NOAA FORM 76-35A	
U.S. DEPARTMENT OF COMMERCE NATIONAL OCEANIC AND ATMOSPHERIC ADMINISTRATION NATIONAL OCEAN SERVICE	
DESCRIPTIVE REPORT	
Type of Survey	Hydrographic
Field No.	RA-10-9-98
Registry No.	H-10815
LOCALITY	
State	Alaska
General Locality	Lynn Canal
Sublocality	Sullivan Island and Vicinity
1998	
CHIEF OF PARTY CAPT A.D. Anderson	
LIBRARY & ARCHIVES	
DATE	AUG 30 1999

Descriptive Report to Accompany Hydrographic Survey H-10815

Field Number RA-10-09-98

EVALUATION REPORT

ATTACHMENT 1
 H-10815 LIMITS DEPICTED ON CHART 17317
 18th EDITION, JUNE 14, 1997.
 LIMIT LINE DENOTES AREA OF SUPERSESSON.

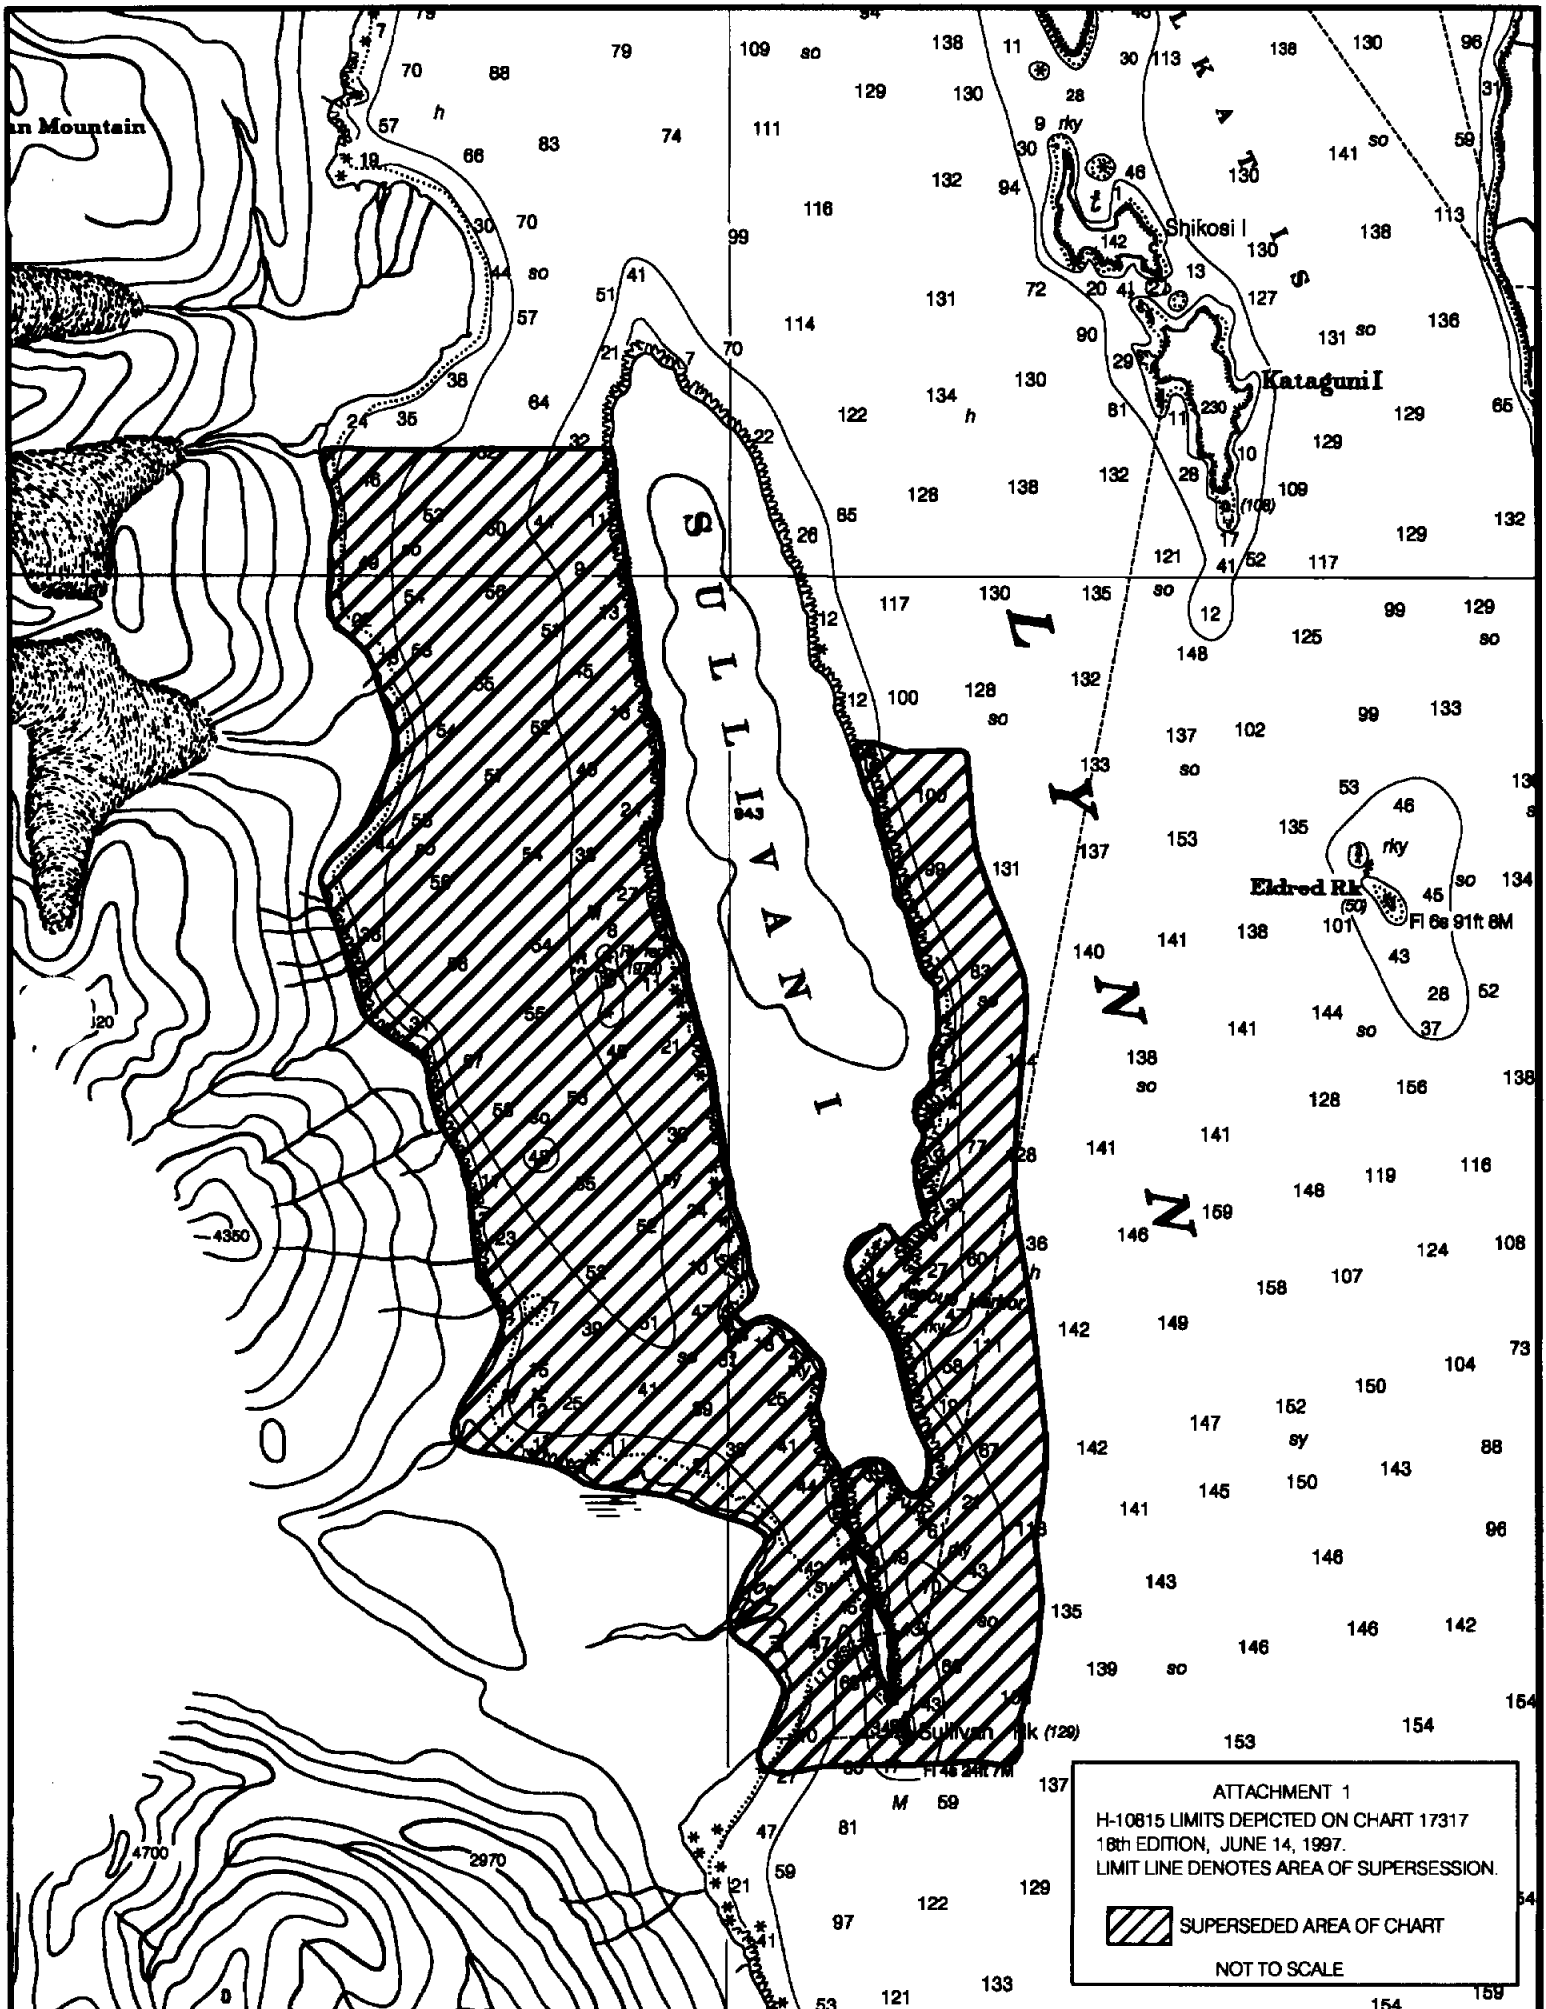
The hydrographer has determined the inshore limits of safe navigation by defining a Navigable Area Limit Line (NALL) throughout the survey area. Charted features and soundings inshore of this limit line have not been specifically addressed during survey operations and should be retained as charted. A page-size plot of the charted area depicting the specific limits of supersession accompanies this report as Attachment 1.
